2016 - 2017 Cadillac ATS-V and CTS-V: GM TechLink: #16-NA-399: Information on Replacing Half Shaft Fasteners with Revised Parts

#16-NA-399: Information on Replacing Half Shaft Fasteners with Revised Parts - (Feb 28, 2017)

Subject: Information on Replacing Half Shaft Fasteners with Revised Parts

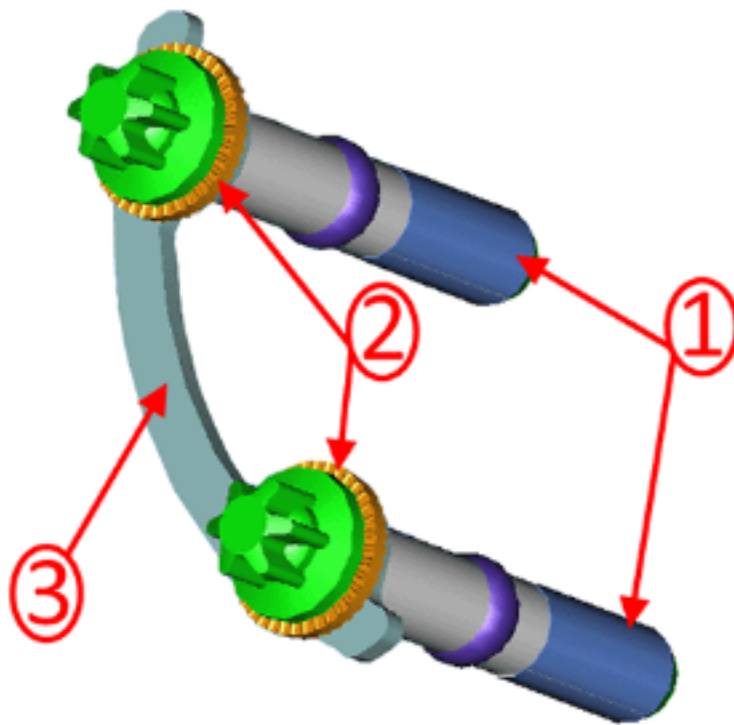
This bulletin advises the Service Technician of new retainer assemblies that are required to be installed during any repair that requires the half shaft bolts to be removed or replaced.

- Three retainer assemblies required per half-shaft.
 - Each retainer assembly consist of 2 longer length bolts (1), 2 lock washers (2) and 1 retainer (3).
 - Where applicable, each axle assembly uses 3 retainer assemblies per side.
 - Replacement of *all* retainer assemblies are required during repair.

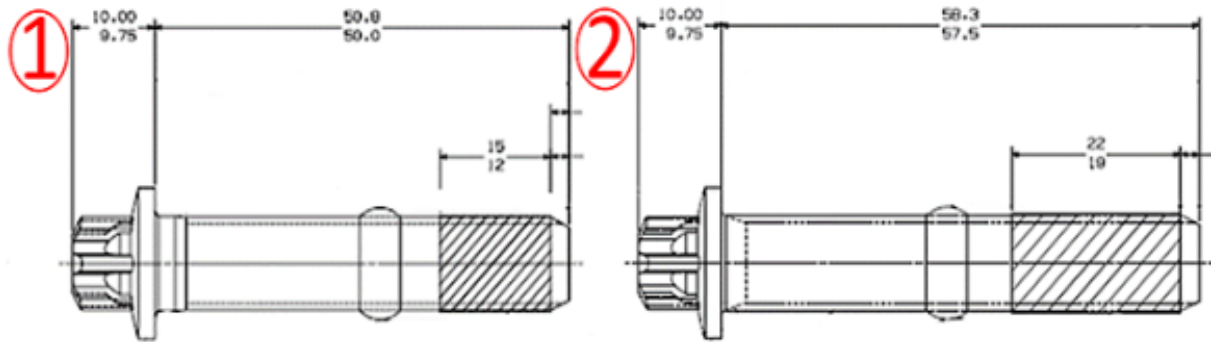
Service stock half shafts may include POA retainer assemblies that have the shorter bolt (1), these assemblies may require to be exchanged with new retainer assemblies that have the longer bolts (2).

- The new half shaft bolts must be removed, measured and discarded if the length is incorrect.

- Remove and discard retainer assemblies.
- Install new retainer assemblies.
 - Torque bolts to proper torque specifications. Refer to
